ADDENDUM No. 1

ITB No. 4685

2021 SIDEWALK GAP ELIMINATION

CITY OF ANN ARBOR - PUBLIC SERVICES - ENGINEERING
TRAVER BLVD
MAINTENANCE OF TRAFFIC

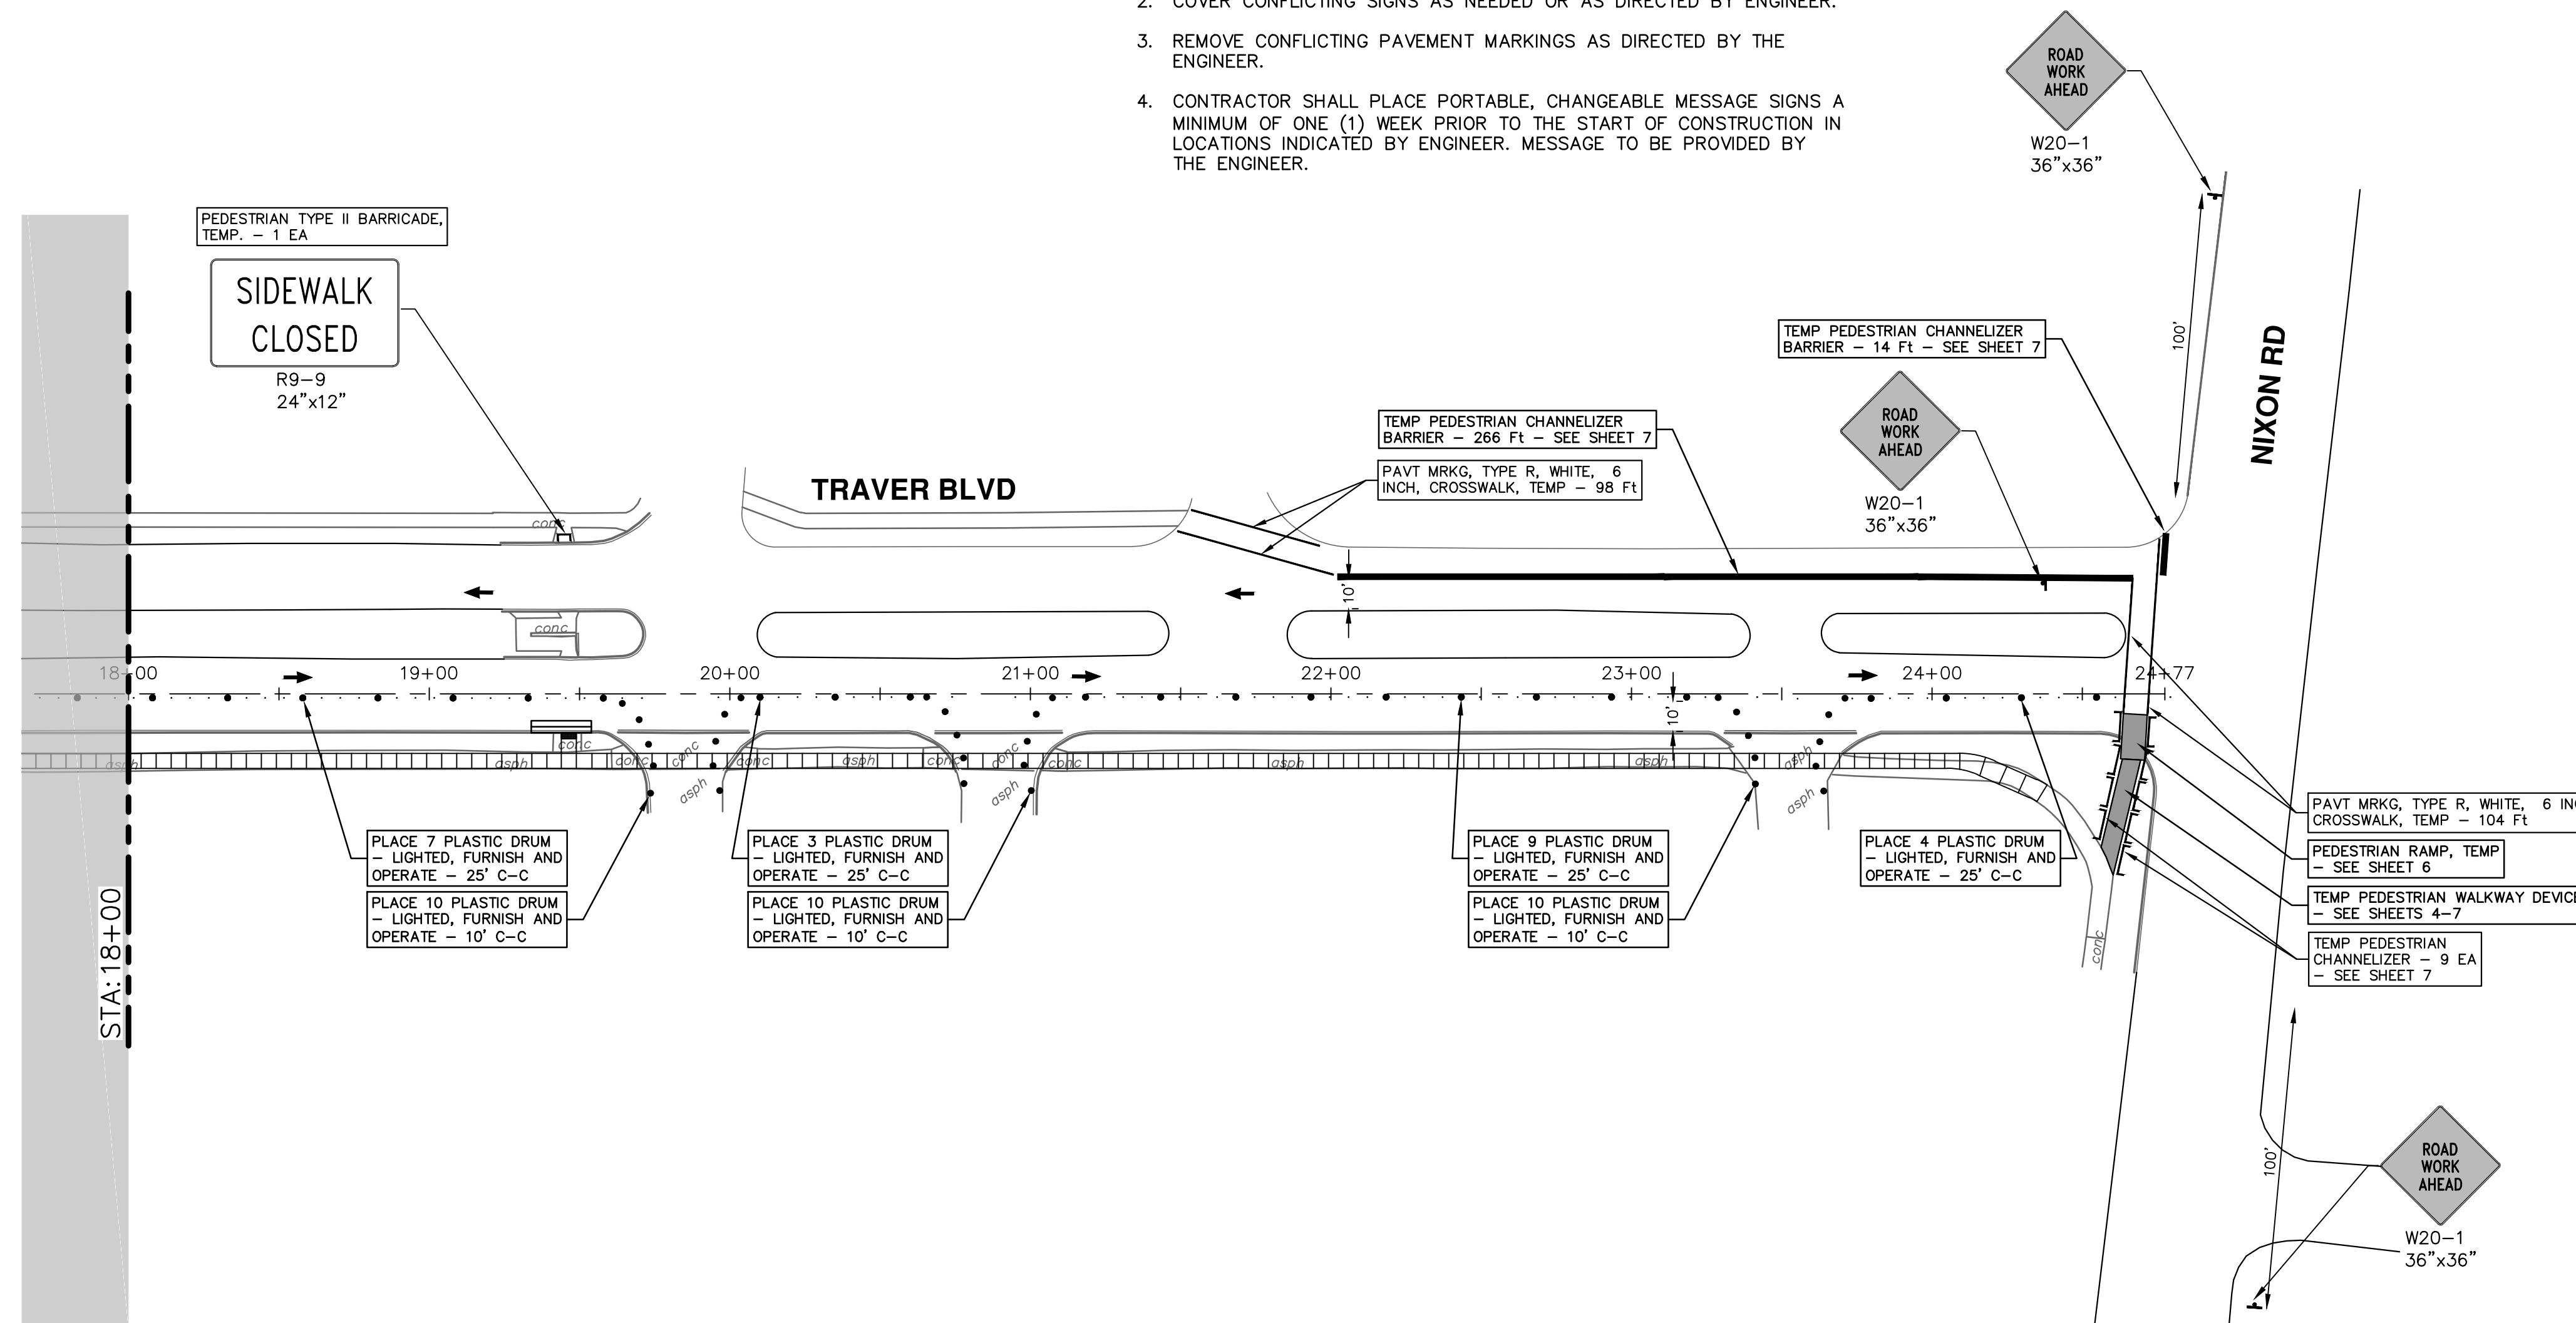
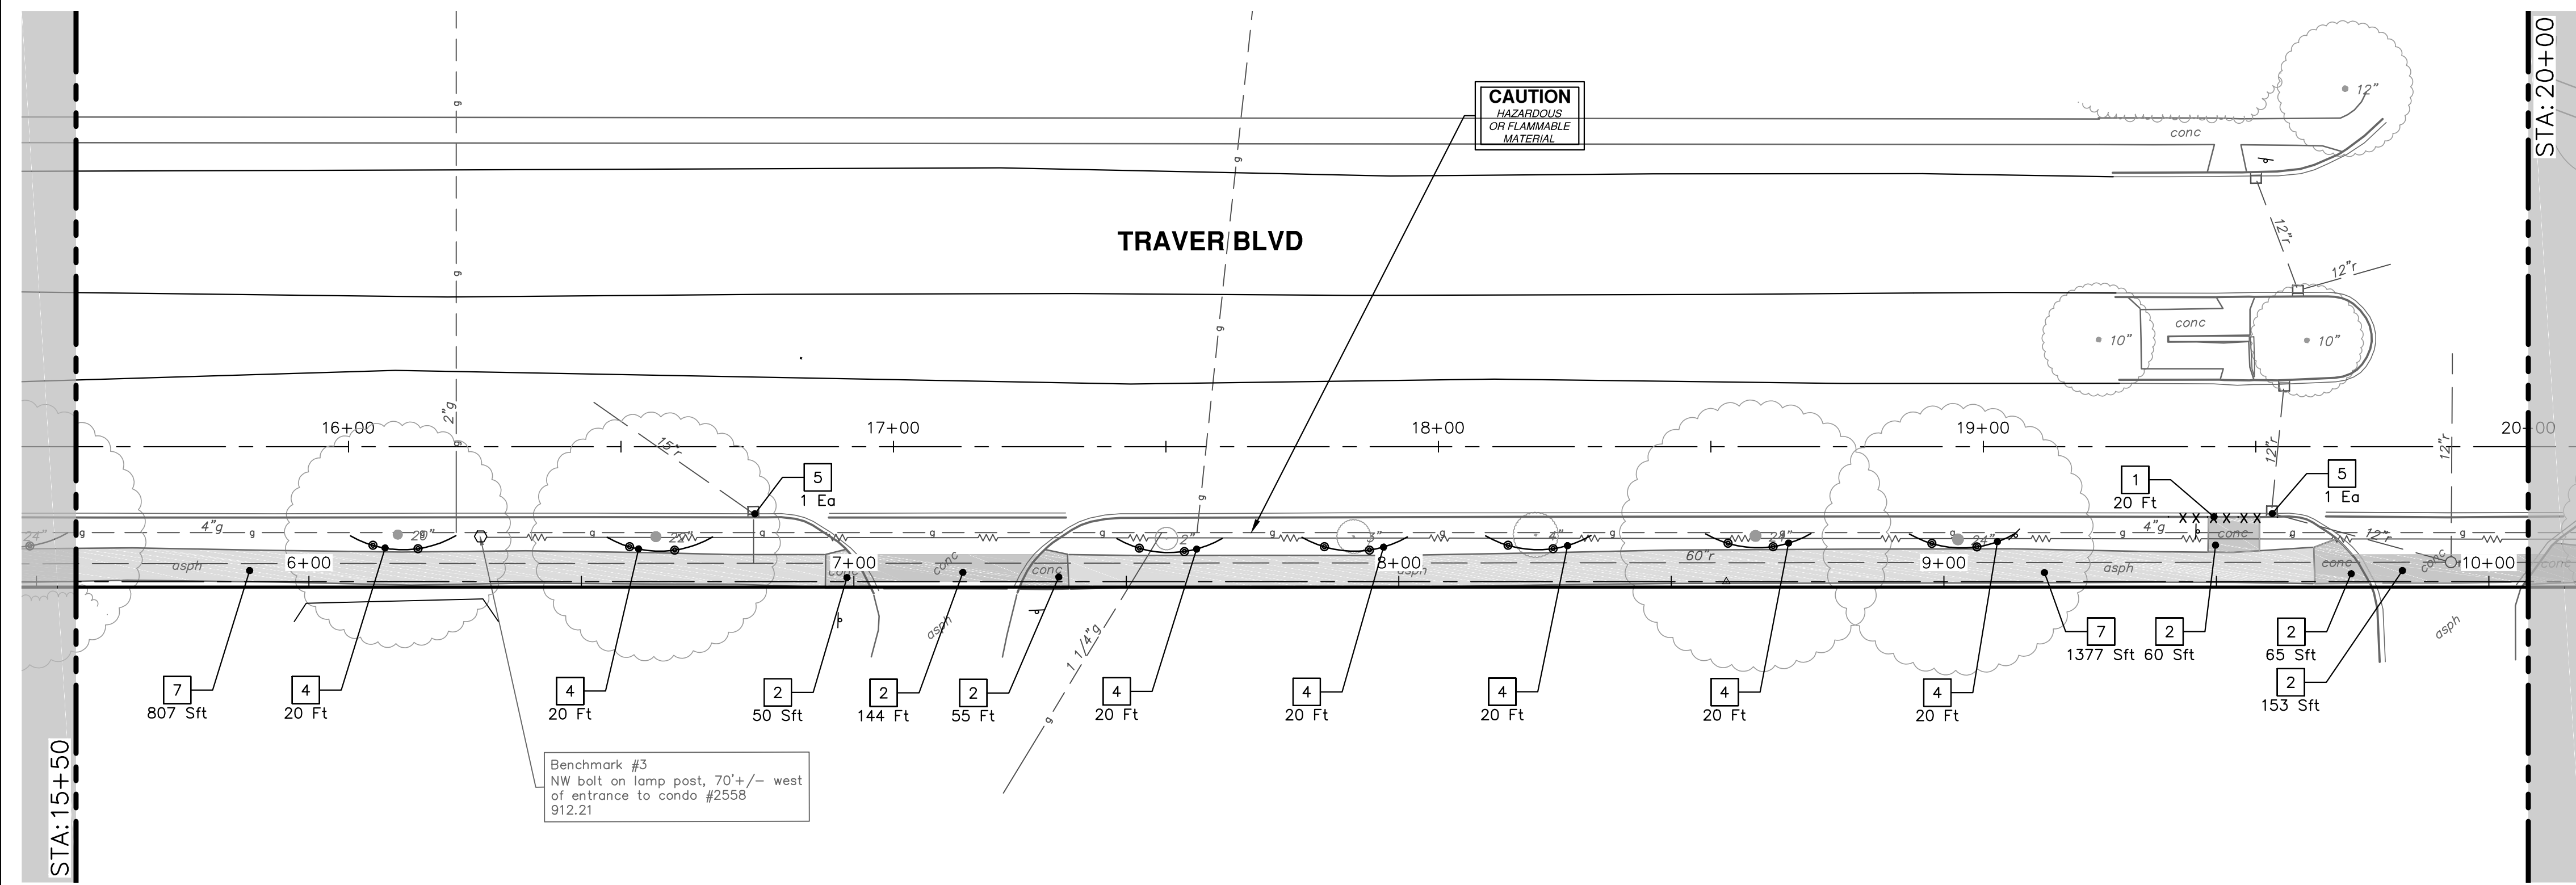
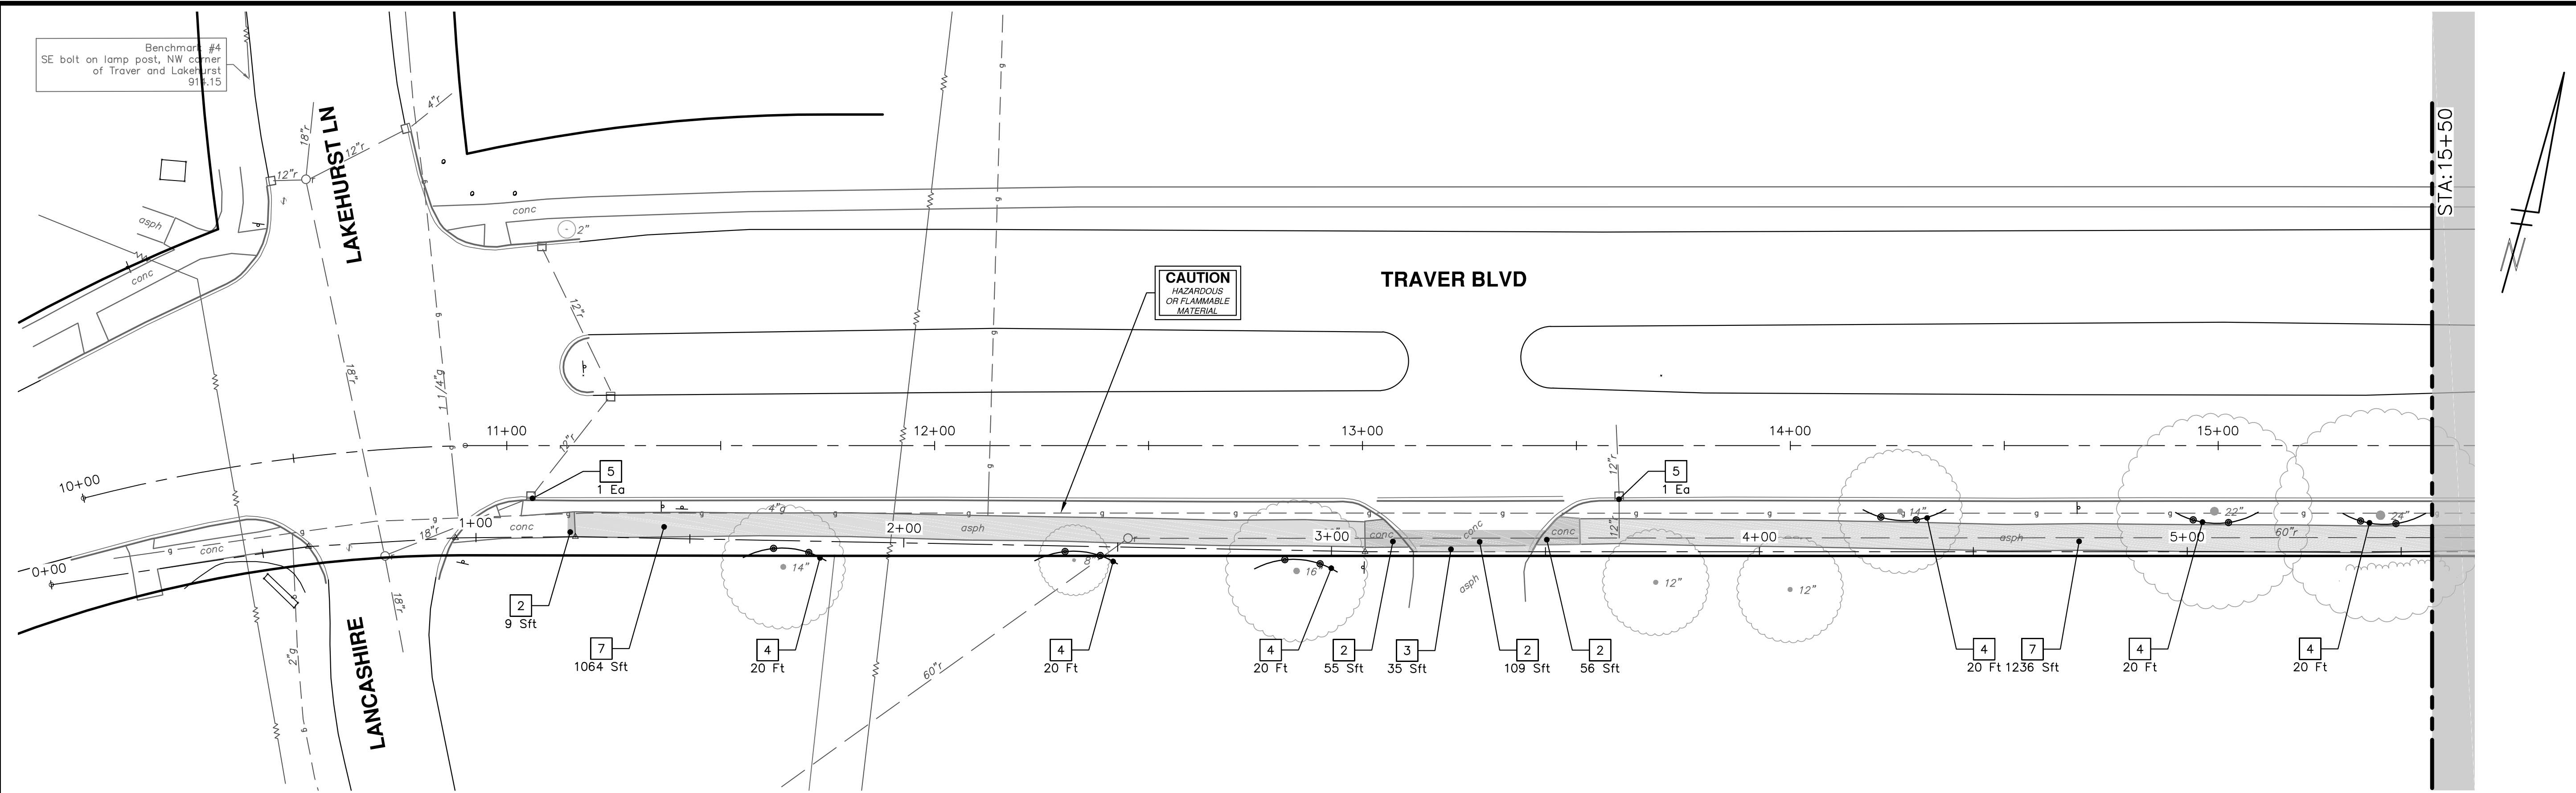
Drawings/1	Revised Sheet List Table.
Drawings/2	Revised Construction Notes 7-9, 12, 14.
Drawings/11	Revised sidewalk type on the southwest corner of Barton and Northside.
Drawings/11-13	Profile grade labels indicate location south face of walk.
Drawings/17	Extended lane closure on north side; indicated temporary pavement markings; added pedestrian routing.
Drawings/18-19	Reduced removal and replacement limits on south side at east and west ends; added temporary grading easement.
Drawings/20-21	Added profile information.
Drawings/23	Removed barricades at southerly most driveway
Drawings/24	Revised sidewalk type through driveways to eliminate fibermesh
Drawings/25	Added pedestrian routing; reduced scope of MOT, eliminating north side of Traver and corners of Traver and Lakehurst/Lancashire intersection.
Drawings/26-29	Eliminated removal and replacement in median, at north side of Traver, and at all corners of Traver and Lakehurst/Lancashire intersection; eliminated extension of median at east leg of Traver and Lakehurst intersection.
